Subject: River Bend Station - Unit 1
Docket No. 50-458
License No. NPF-47
Response to Request for Additional Information, Ampacity Derating
(TAC No. M85596)
File Nos. G9.5, G9.33.4

RBG-43571
RBF1-96-0477

ATTACHMENT A

Responses to Request for Additional Information

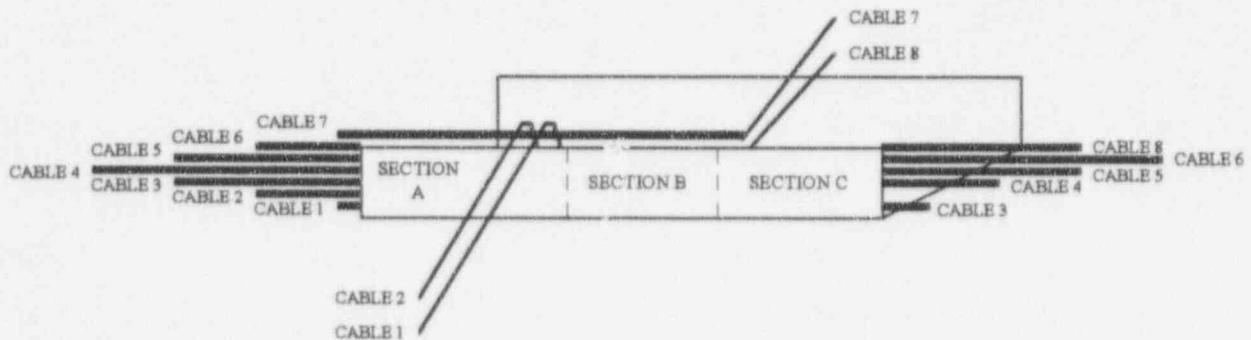
The licensee implies that the subject analysis will "calculate the depth of cables in each wrapped tray (other than control cables)" and will "use this value to determine an ampacity derating adjustment for cable depth." It is not clear whether those control cables which run in raceways with power cables will be included in depth of fill calculations. The staff agrees with our contractor, Sandia National Laboratories (SNL) that the thermal insulation effects of low or non-continuously energized cables must be accounted for in the subject analysis [see Attachment 1(a)]. The licensee is requested to clarify the use of subject assumption in the applicable calculations.

It is important to realize that the PDMS tray fill calculation is conservative because PDMS assumes that if a cable is in the tray anywhere, it is in the tray everywhere. The following figure and discussion explains this point.

E-218, DRAFT Revision 1 and the associated PDMS ampacity computations do not use an assumed tray depth. The ampacity computation uses the results of the PDMS tray fill calculation to compute the ampacity of random lay cables in K (600 Volt power) and C (600 Volt control) trays. PDMS calculates tray fill by summing the cross-sectional areas of all cables in the tray, irrespective of cable type, and then dividing by the tray cross-sectional area. In K tray, control cables may be present with the power cables; PDMS includes these in the calculation. Therefore, the results of PDMS ampacity computations are based on tray fill (or depth) that includes all cables in the tray.

Tray section A contains 7 cables (1 through 7), section B contains 5 cables (3 through 7), and section C contains 5 cables (3 through 6 and 8). None of the three tray sections contain all 8 cables. However, PDMS computes tray fill by summing the cross-sectional areas of every cable that enters or leaves the tray. In this example, PDMS computes tray fill based on the 8 cables in each of the three sections.
